January 29, 2014

RE: Final Improvements to Project #606376, Cambridge Street bridge over I-90, Allston, Boston

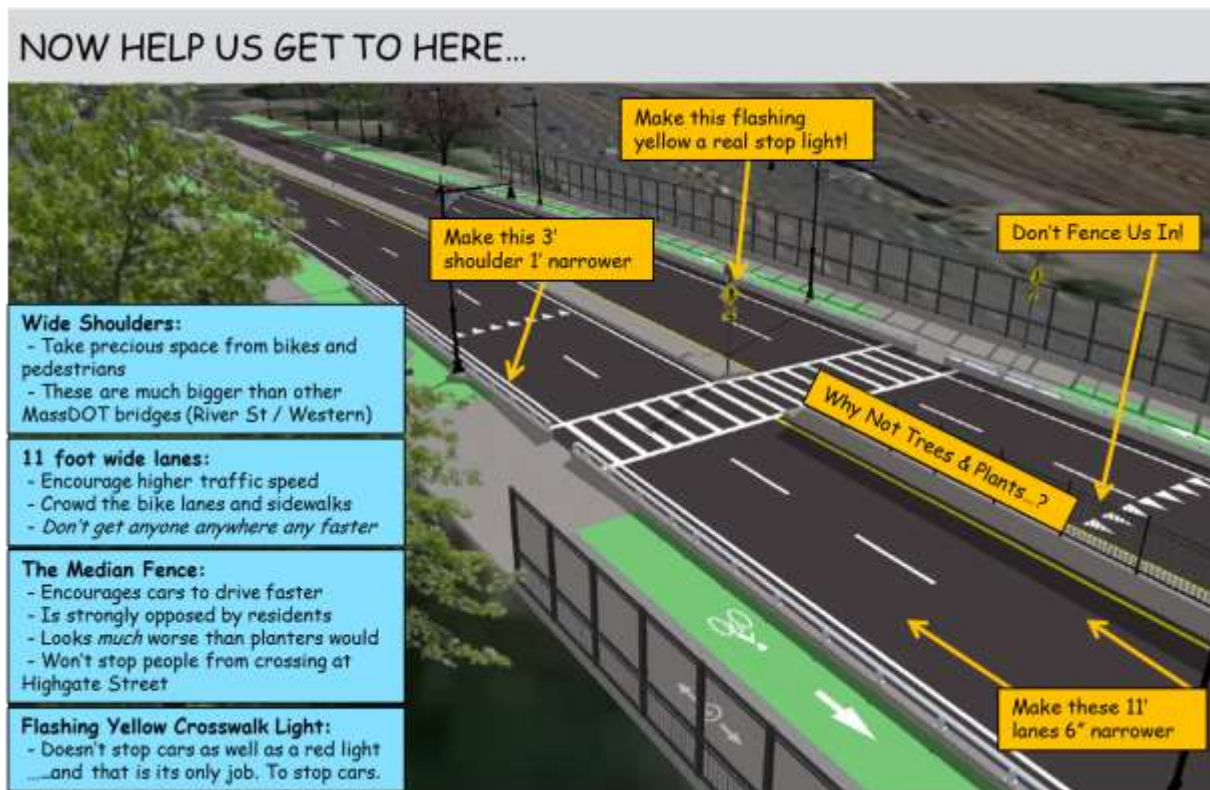
The image below, from the Web page <http://cambridgestreetoverpass.blogspot.com/> shows activists' proposal for what they describe as improvements to the MassDOT plan. I agree with *one* of these proposals: a better traffic signal, and partially agree with another, removal of the median fence.

The blog post proposes to resolve bicycle-pedestrian conflicts by drastically restricting bicyclists, placing a row of planters between the sidewalk and the bikeway. The planters would allow only about a two-foot range for a bicyclists' wheel track without risk of snagging a pedal on a planter, guardrail or lamppost. There would be only room for a single line of bicyclists, all would be restricted to the speed of the slowest. Imagine a bicyclist trying to get somewhere, unable to a family with a child on a tricycle traveling at 5 miles hour! Contraflow bicycle traffic would use the walkway, which will be just as narrow. The planter configuration would not allow street cleaning machines, or space to to store plowed snow either from the sidewalk or from the bikeway. The predictable result would be to divert faster bicyclists back out onto the roadway, which also would be narrowed further with a 2-foot shoulder adjacent to a 10.5 foot travel lane. This is explained as a traffic calming measure. It is a truism among activists narrowing travel lanes slows traffic, but in fact, the effect is minimal, and particularly when traffic is light.

The blog, and also an activists' letter, see <http://tinyurl.com/knazotg>, plead for elimination of a fence in the median. Pedestrians would be fenced in even without a fence in the median, having to step awkwardly over a guardrail at either side of the street, as shown in the image on page 2. There is certainly is no need for a fence 6 feet high, and in the section with guardrails, there is no need for a fence at all.

I stand by my suggestions in my previous letter for bike lanes on the roadway. I ask why the bridge superstructure might not be widened, as with the Harvard Bridge, to allow wider sidewalks – perhaps in the upcoming bridge replacement – but lacking that, I recommend 10-foot wide sidewalks, with shared use by pedestrians and bicyclists, wider in the on-land section between the Franklin Street overpass and Harvard Avenue, where there will necessarily be heavier two-way bicycle traffic. 10-foot sidewalks would be wide enough to accommodate pedestrians and family cyclists, and would leave room on the roadway for bike lanes wide enough for one bicyclist to overtake another. The bike lanes could be separated by flexposts if desired in the uphill segments where there is no need for bicyclists to merge to the left.
